Test procedure for OVC-FCHV´s

Proposal for GTR 15 modification

Figure A8.App 1/4 OVC-HEVs, charge-sustaining Type 1 test with subsequent charge-depleting Type 1 test

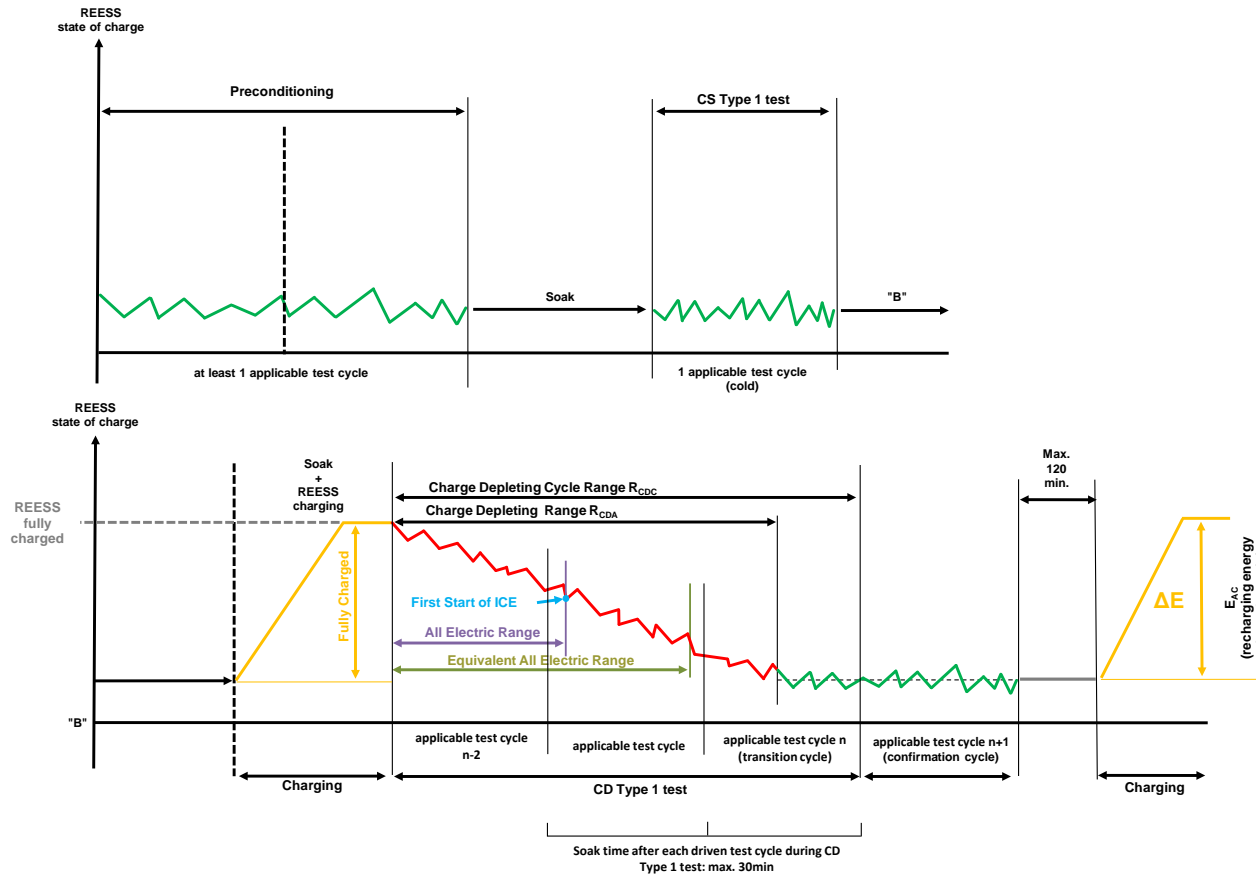
Test procedure for CS is already available

Test procedure for CD exist only for OVC-HEV but this procedure can also be used for OVC-FCHV if CO₂ is replaced by H₂ in the relevant formulas
